CNG Gen 3 RM Refuse Fuel System PRD Retrofits

Agility Fuel Solutions LLC, a subsidiary of Hexagon Agility Inc. (Hexagon Agility®), has determined that certain OMB pressure relief devices (PRDs) have been observed to crack or fracture. The PRD failure mode—seen to occur at or near first fill—can result in a sudden release of the high-pressure gas contained in the CNG fuel system to the atmosphere.

Hexagon Agility® has created a PRD retrofit kit, p/n 20535030, to correct this issue on Hexagon Agility® Gen 3 roof mount (RM) refuse fuel systems.

FIGURE 1. Parts List — Retrofit Kit, Beta Valve PRD, Gen 3 RM, Hexagon Agility® p/n 20535030

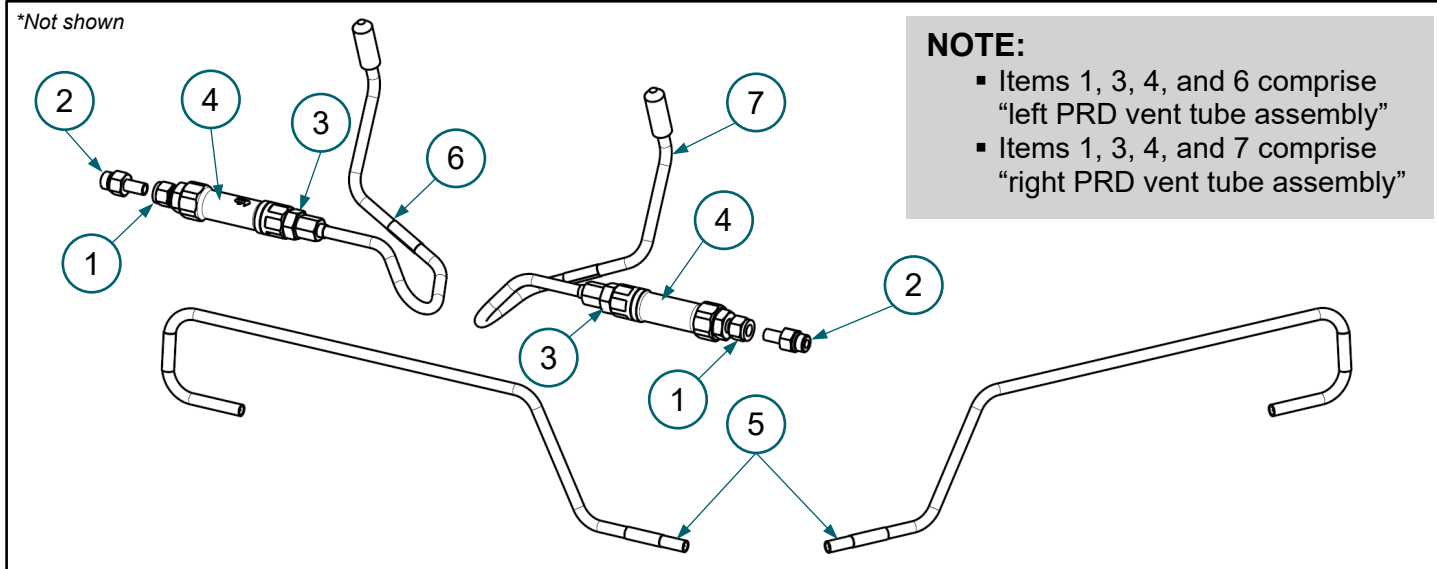
1. Verify contents of Retrofit Kit, Beta Valve PRD, Gen 3 RM, Hexagon Agility® p/n 20535030 is present in the correct quantities. **FIGURE 1**

FIGURE 3. Left fuel system valve end plumbing components

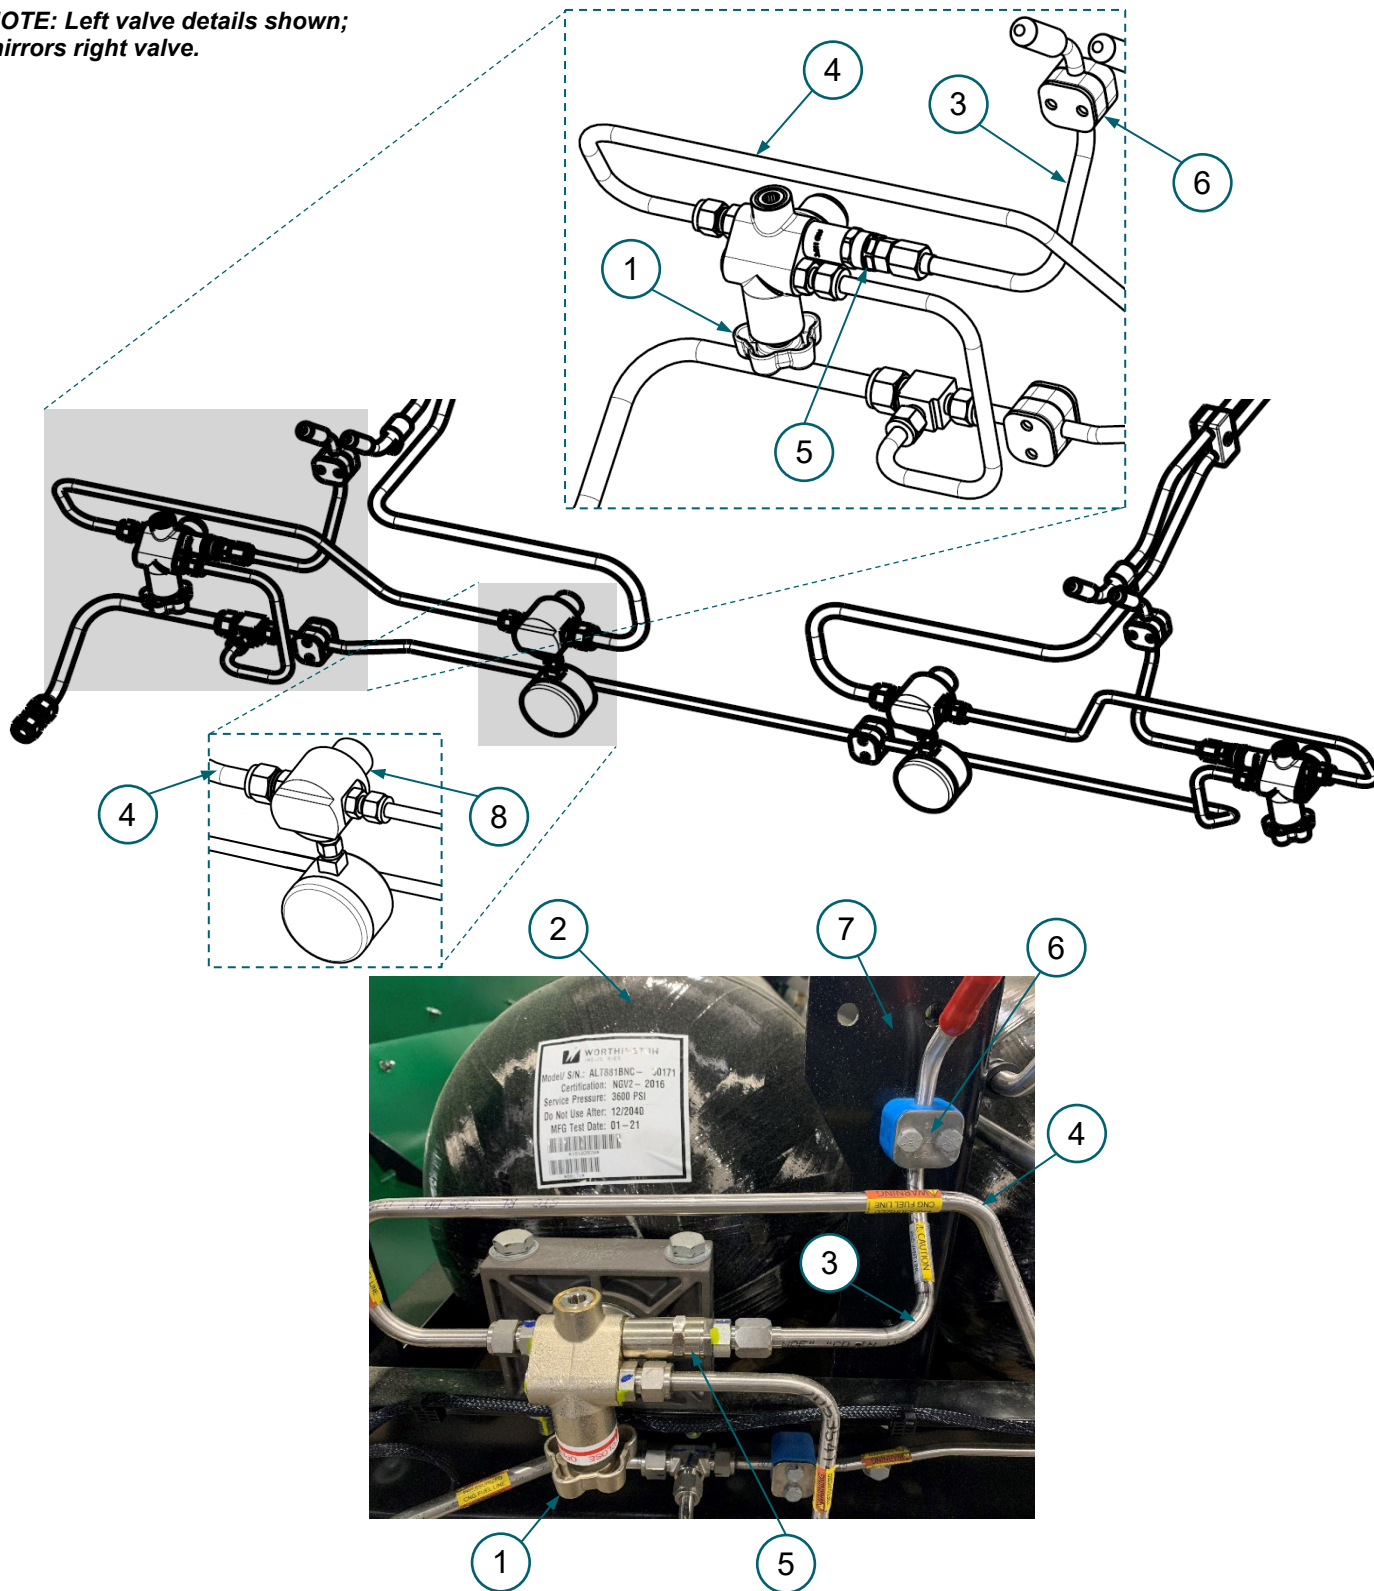
4. Use a pair of 11/16-in wrenches to remove (3) left PRD vent tube from (5) left PRD. **FIGURE 3**

5. Use a pair of 11/16-in wrenches to remove (4) left live PRD tube from (1) left cylinder valve and (8) left manifold. **FIGURE 3**
6. Use a 7/16-in socket and a 7/16-in wrench to remove fasteners securing (6) tube clamp and (3) left PRD vent tube to (7) structure and set fasteners and clamp aside for reuse. **FIGURE 3**

7. Use a 7/8-in wrench to remove (5) left PRD from (1) left cylinder valve. **FIGURE 3**

FIGURE 4. Left PRD vent tube assembly and male tube adapter fitting

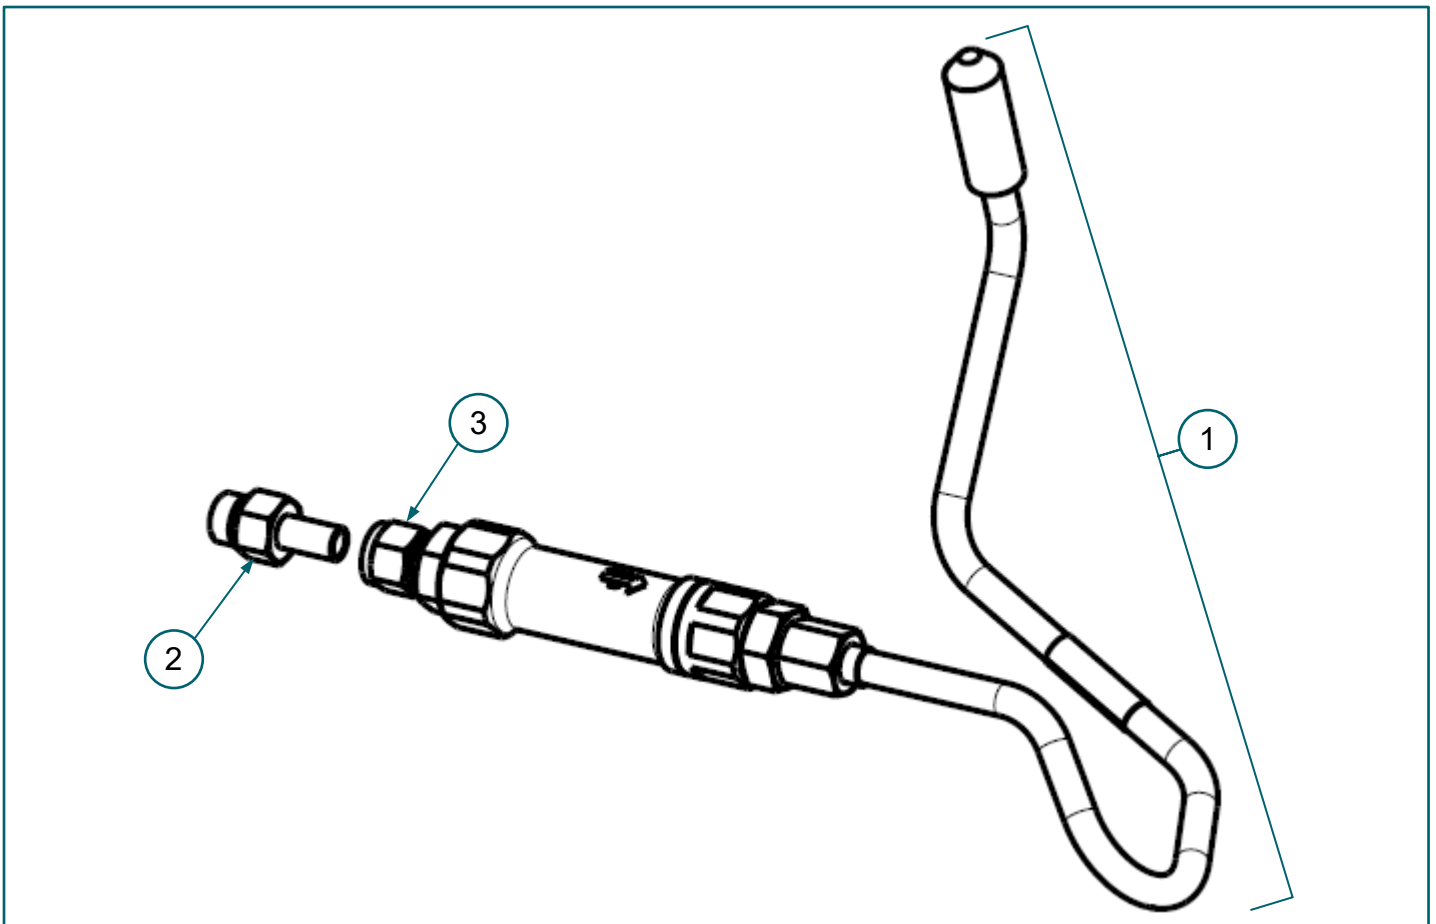
8. Use a 9/16-in wrench to install (2) male adapter fitting, p/n 10200236, from retrofit kit on left cylinder valve (*not shown*). **FIGURE 4**

▼ Torque male adapter fitting to 26 ft-lbs (35.3 Nm).

FIGURE 5: Left cylinder valve plumbing after installation of left PRD vent tube assembly and live PRD tube

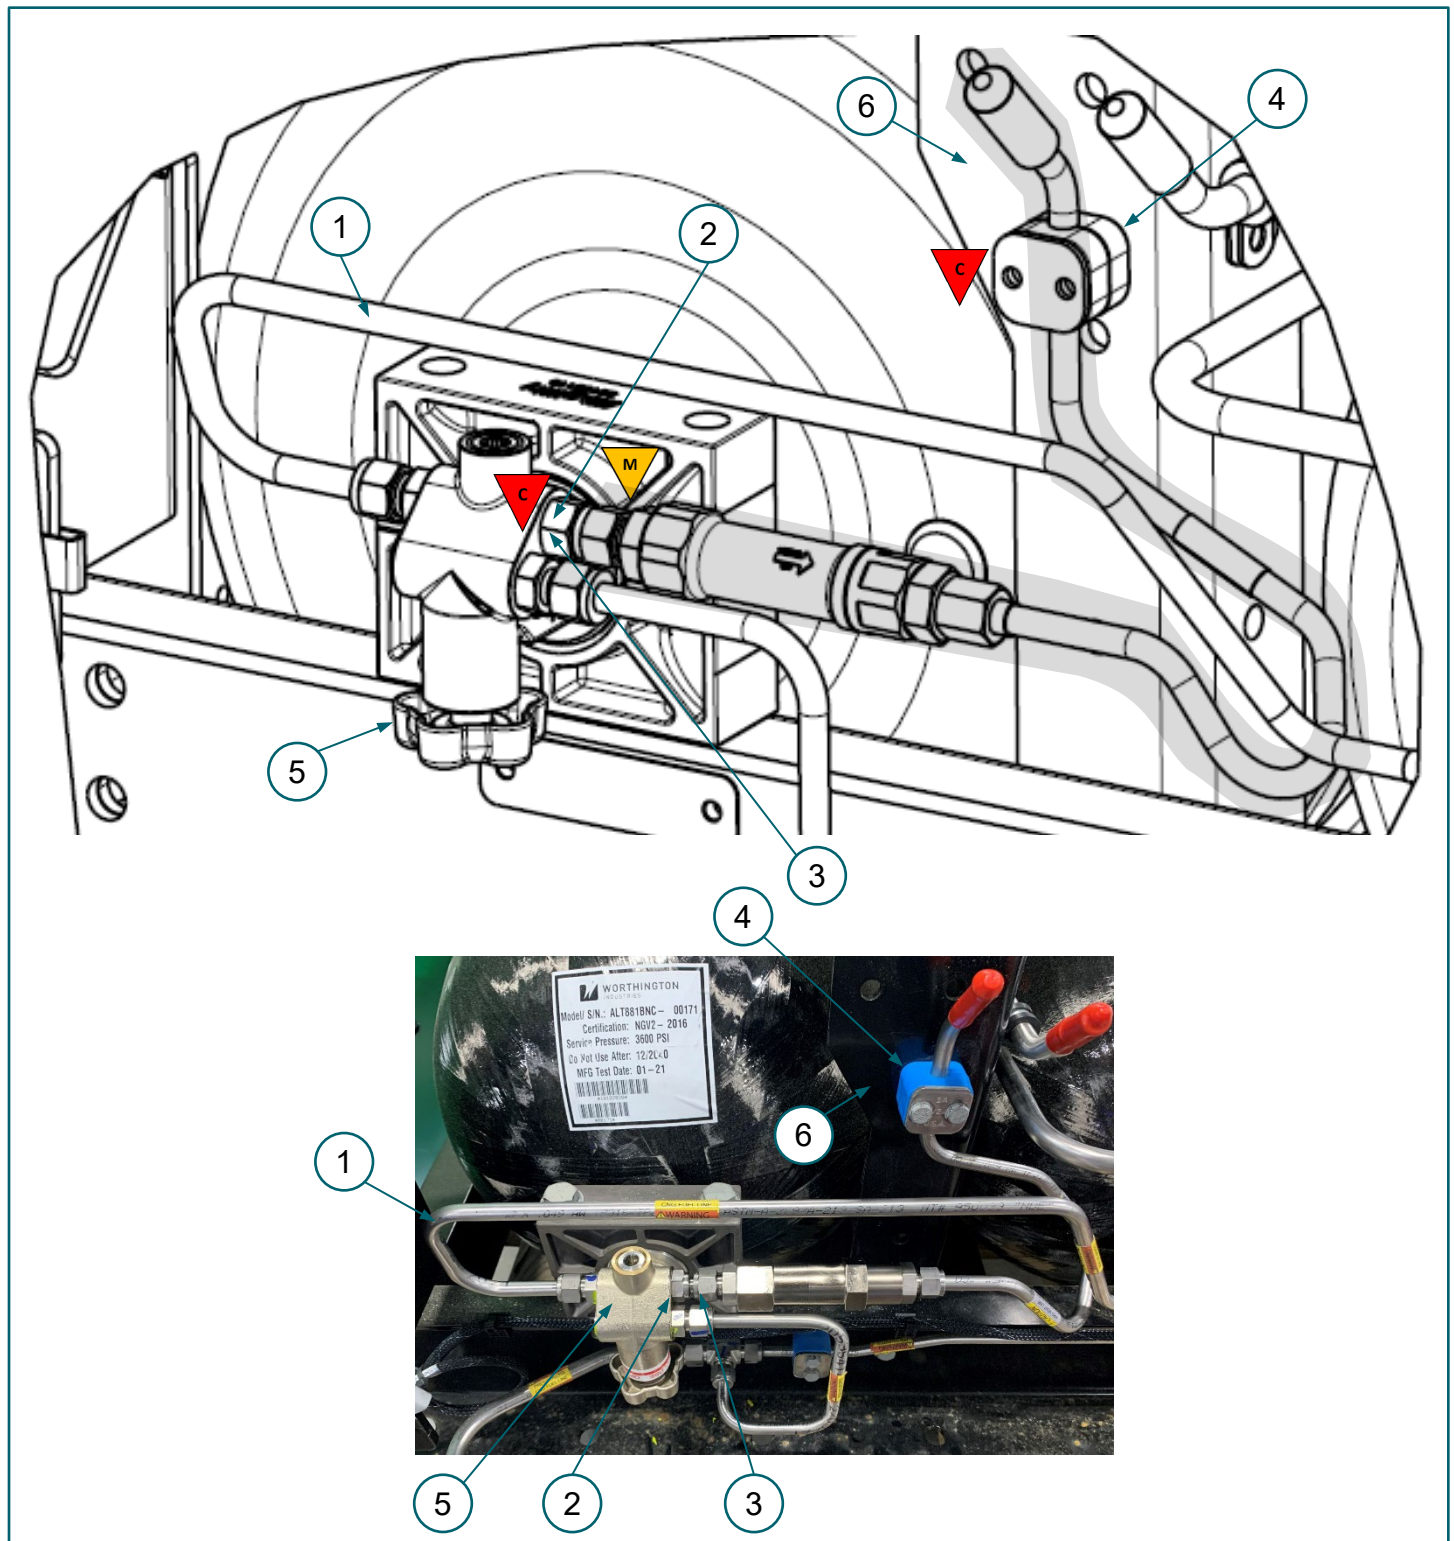
10. Install (1) live PRD tube, p/n 20437408, from retrofit kit on (5) left valve. **FIGURE 5**

11. Use 7/16-in socket and a 7/16-in wrench to secure (*shaded*) left PRD vent tube assembly to (6) structure using (4) tube clamp and fasteners. **FIGURE 5**

Tighten tube clamp fasteners to 8 ft-lbs (10.85 Nm) and mark bolts with Torque Seal.

FIGURE 6. Right fuel system valve end plumbing components

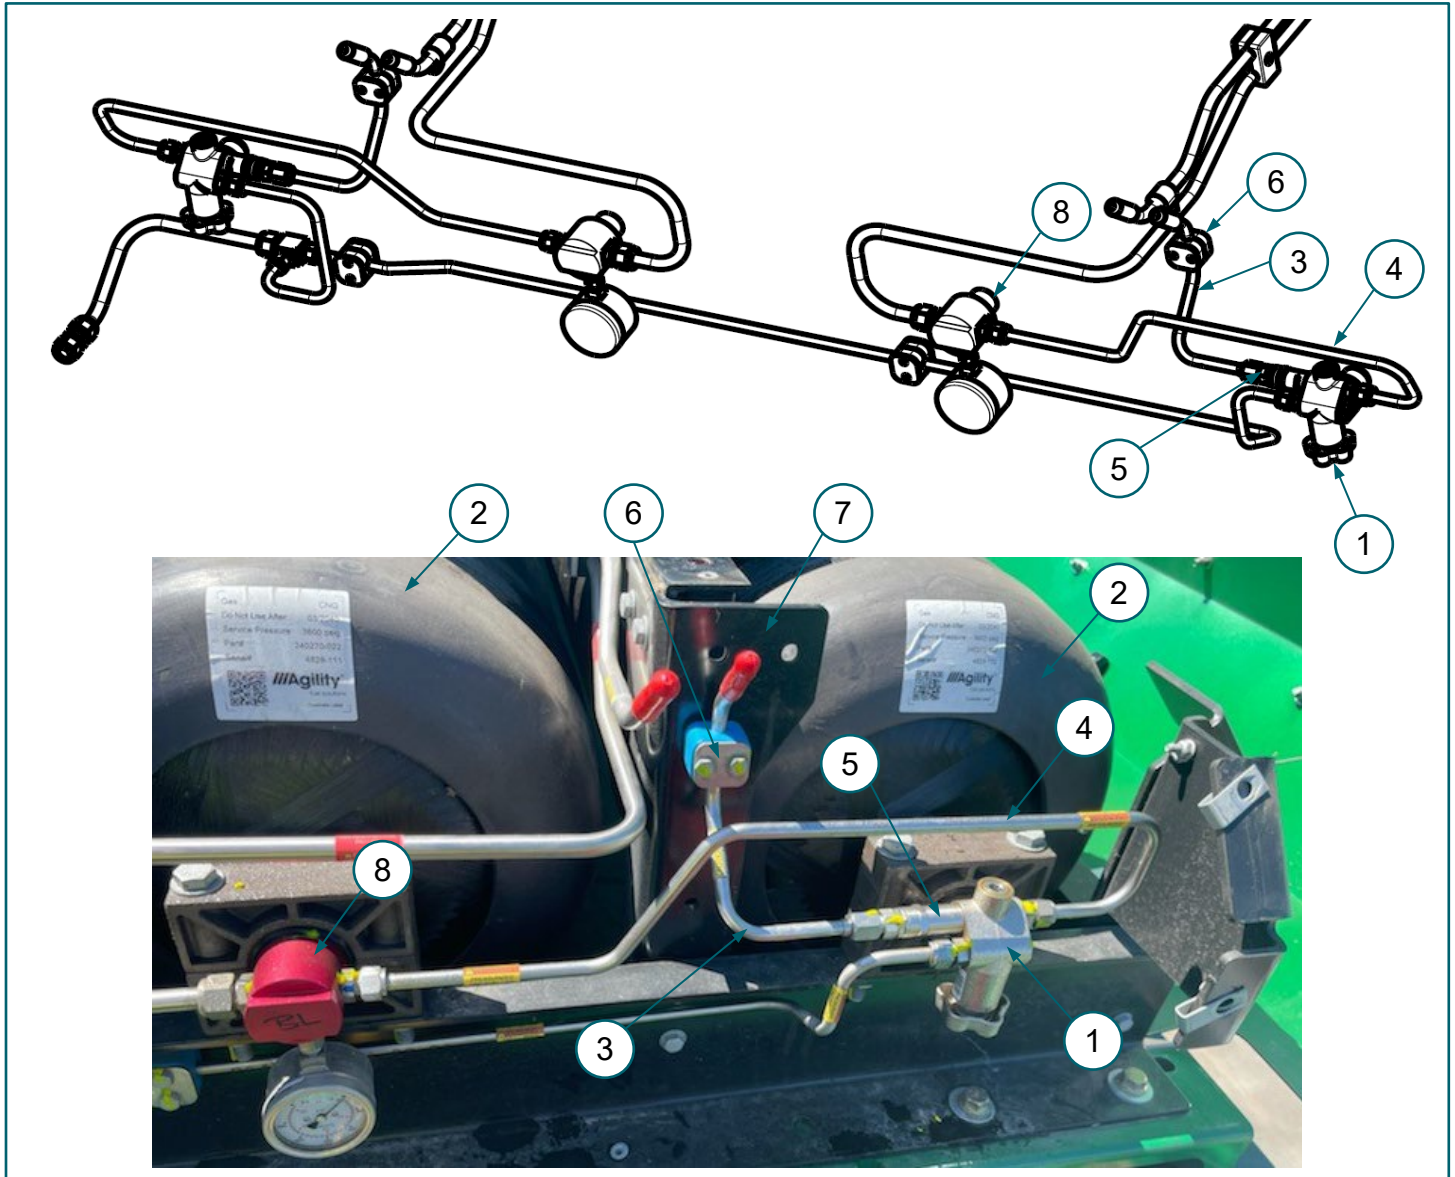
13. Remove (4) live PRD tube from (1) right cylinder valve and (8) right manifold. **FIGURE 6**

14. Remove (3) right PRD vent tube from (5) right PRD. **FIGURE 6**

15. Use a pair of wrenches to remove fasteners securing (6) tube clamp and (3) right PRD vent tube to (7) structure and set fasteners and clamp aside for reuse. **FIGURE 6**

16. Remove (5) right PRD from (1) right cylinder valve. **FIGURE 6**

FIGURE 7. Right PRD vent tube assembly and male adapter fitting

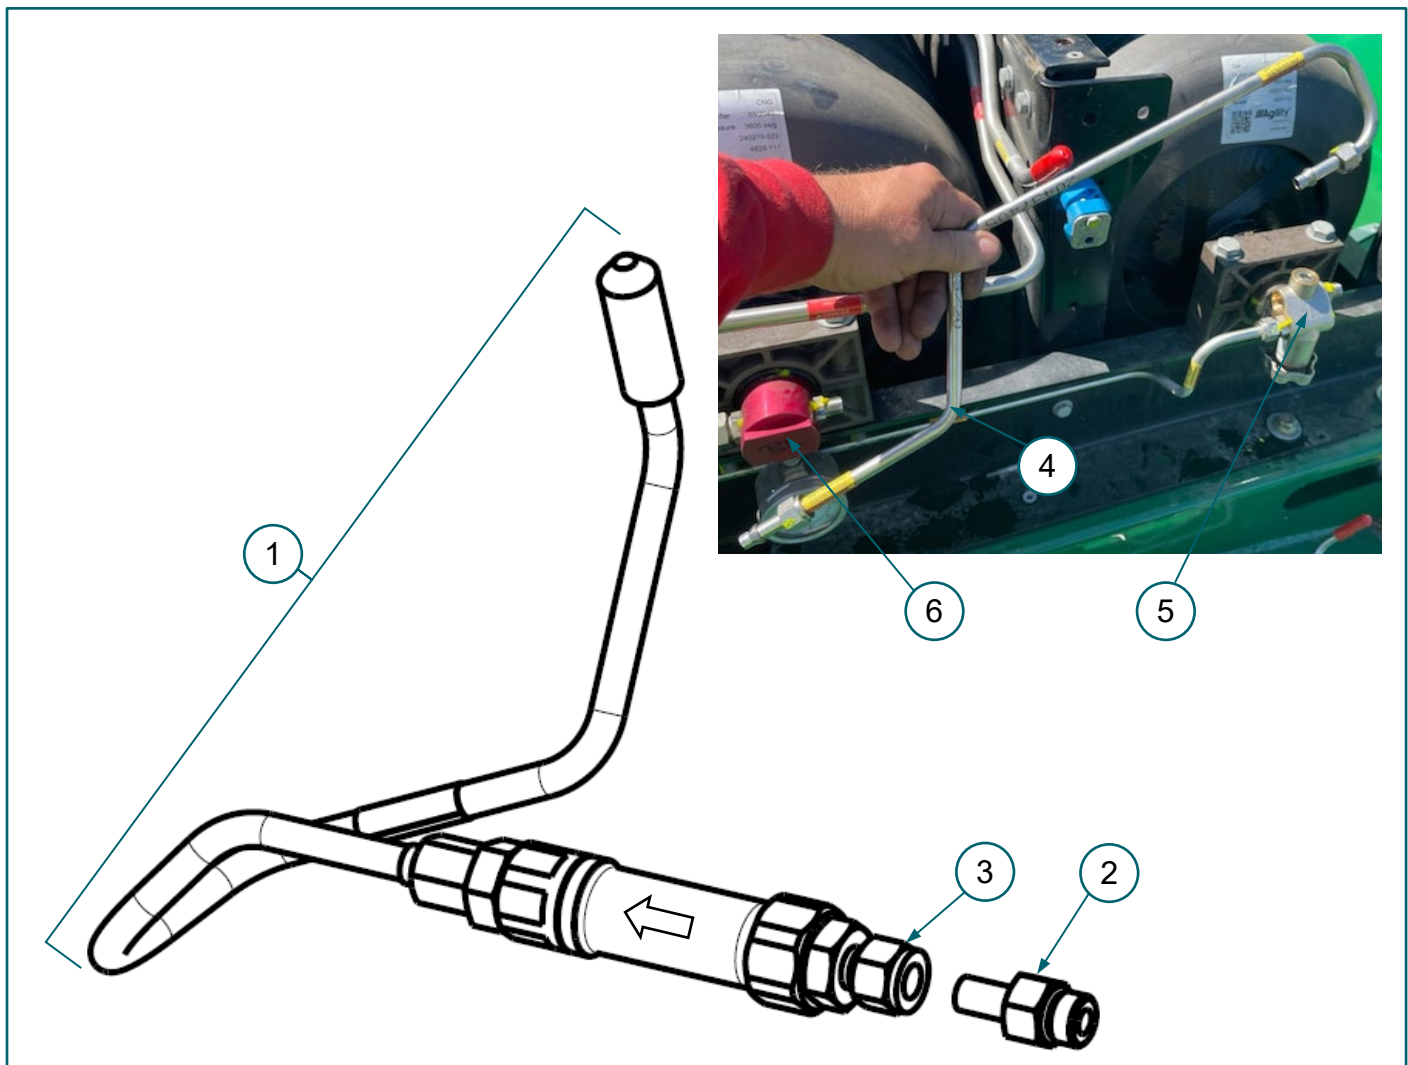
17. Install (2) male adapter fitting, p/n 10200236, from retrofit kit on (5) right cylinder valve. **FIGURE 7**

Torque male adapter fitting to 26 ft-lbs (35.3 Nm).
